Bolton Planning & Zoning Commission
Regular Meeting
7:30 p.m., Wednesday, April 14, 2021
Virtual Meeting utilizing Zoom
Minutes and Motions

a. Discussion/Possible Decision: Special Permit Application for Nursery and Value Added Agricultural Business, 1225 Boston Turnpike, Happy Town LLC (#PL-20-13)

FIGURE 2

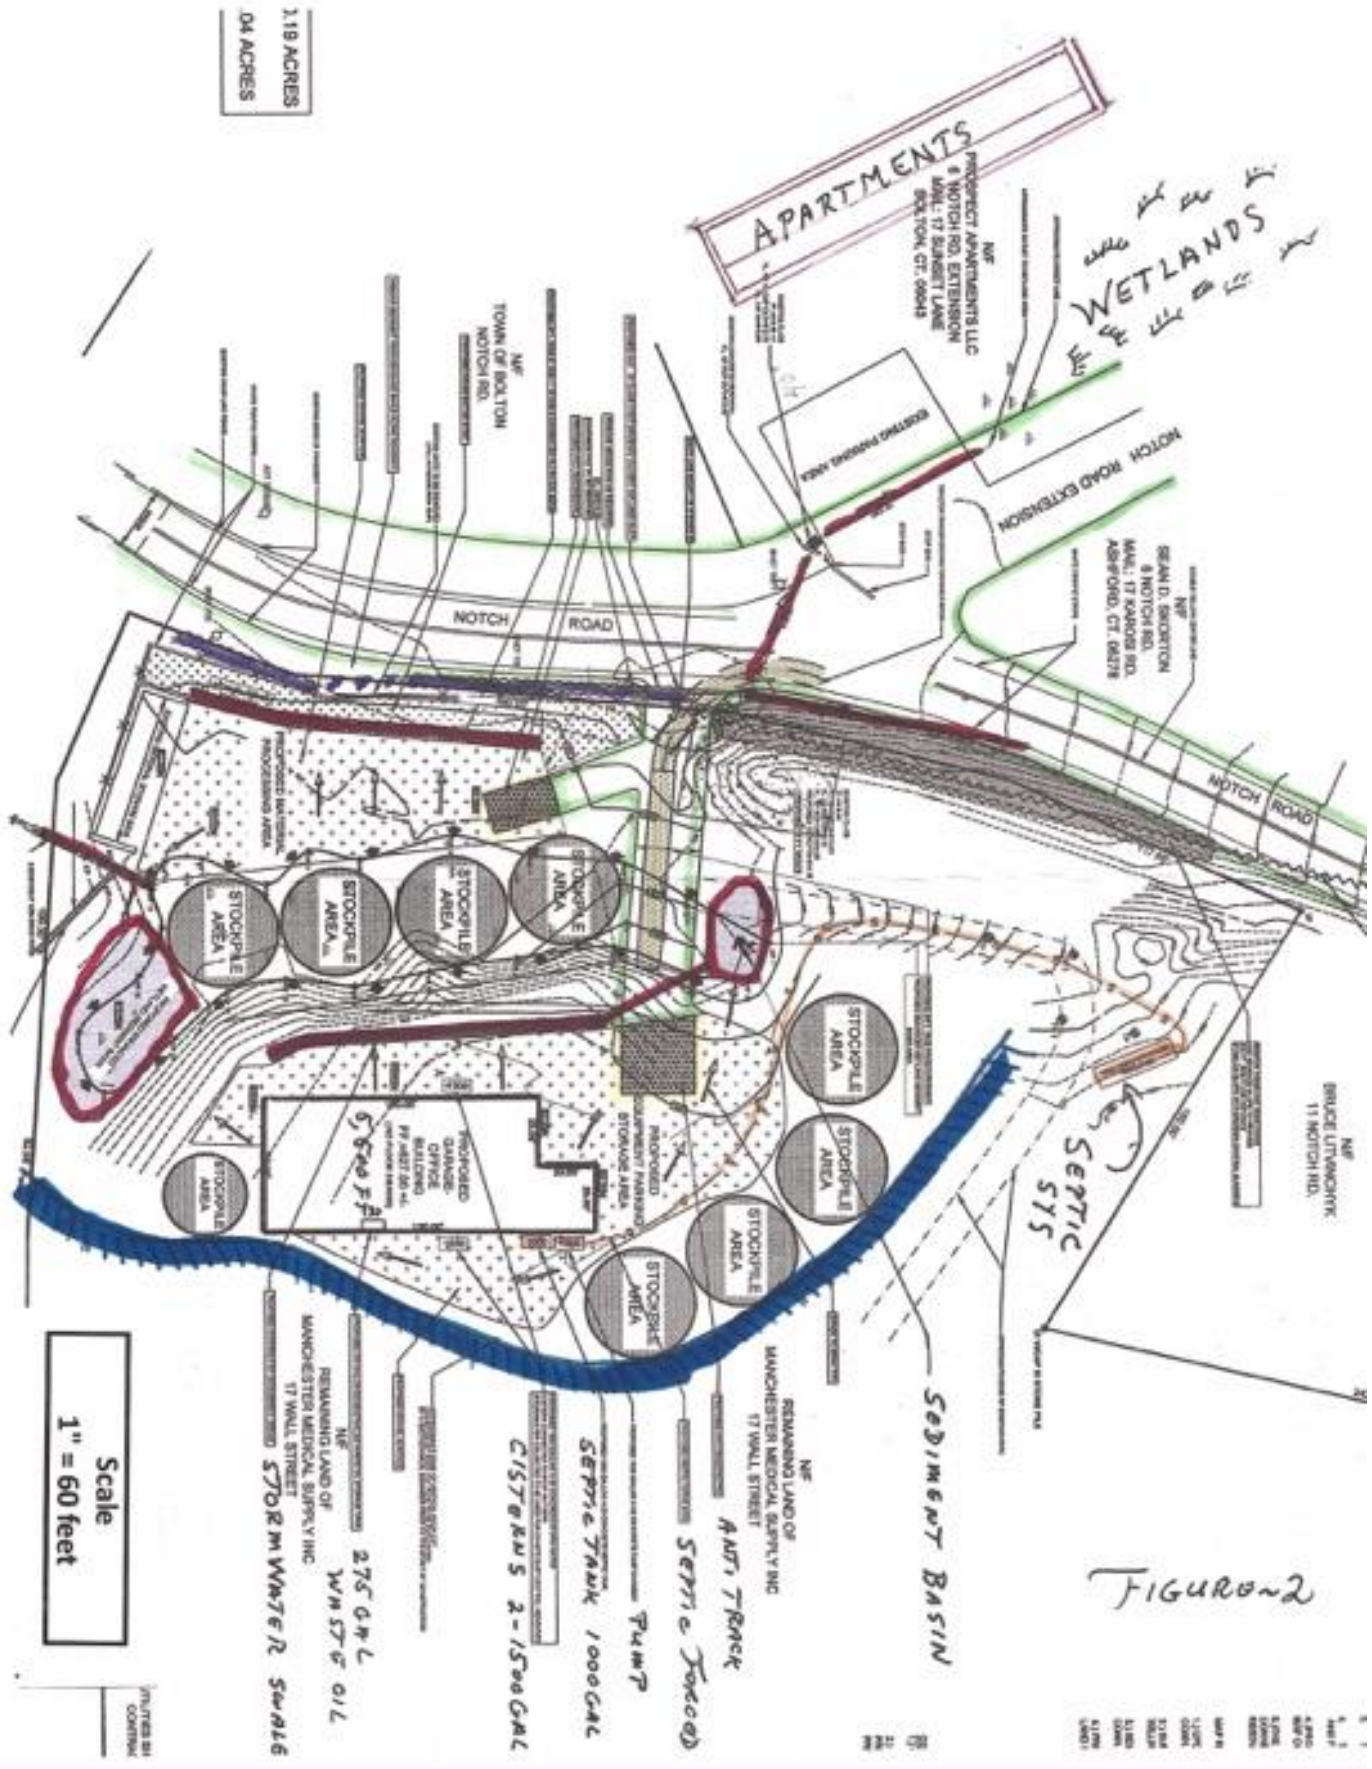
Another noise consideration. The shape of the existing rock quarry wall causes noise to be amplified, directly impacting residents on Notch Rd Ext. and Cook Drive. That wall is definitely reflective. See (Figure 2)

Figure – 3

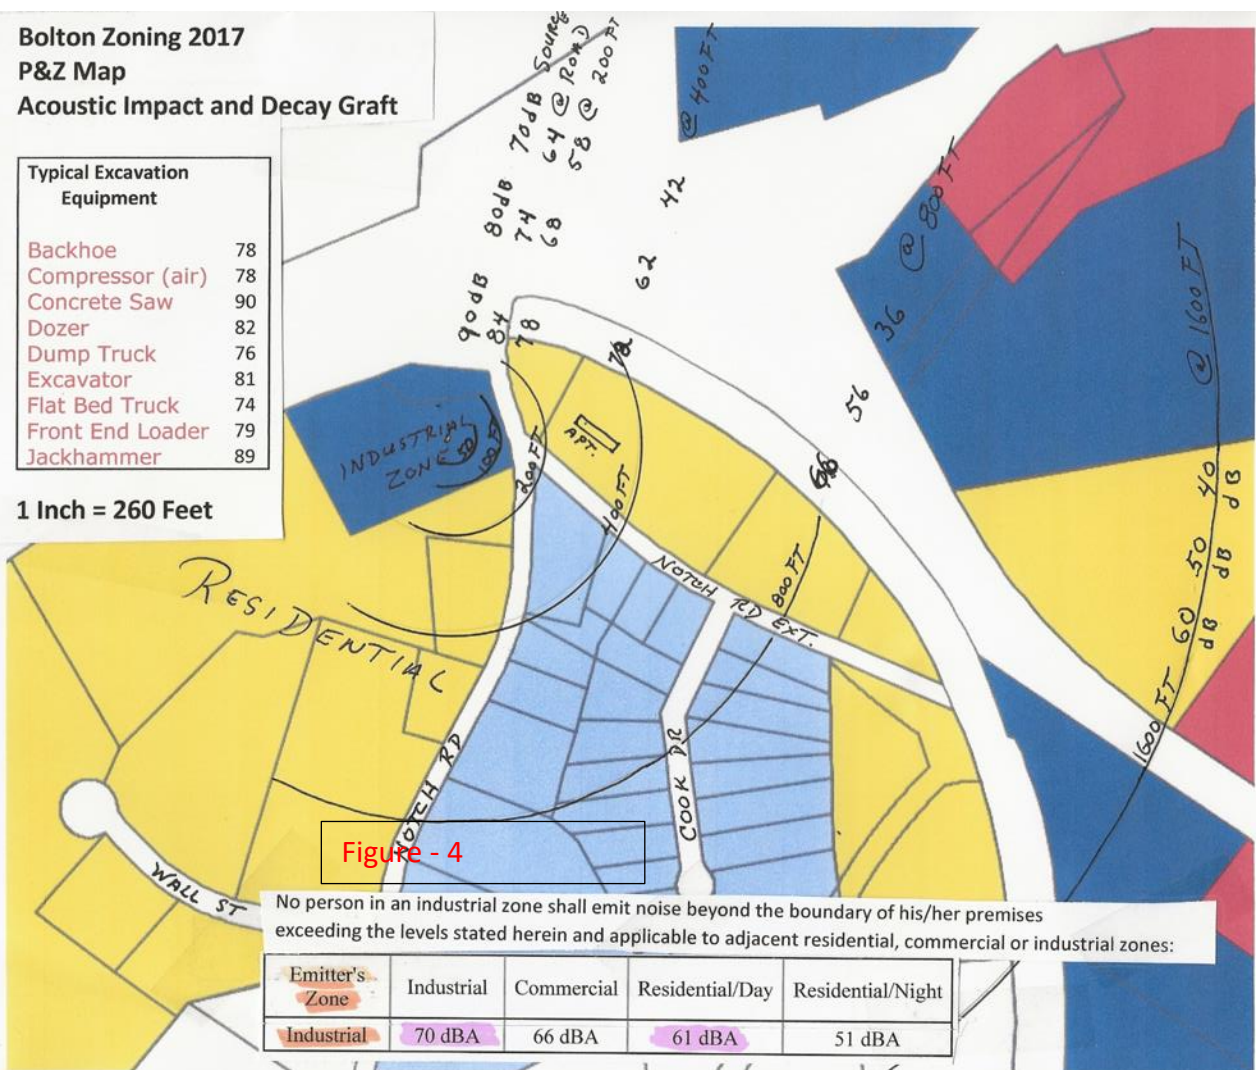
The next residential zone property 6 Notch Road on the corner of Notch Road and Notch Road Extension is also approximately 180 feet. See Figure - 3
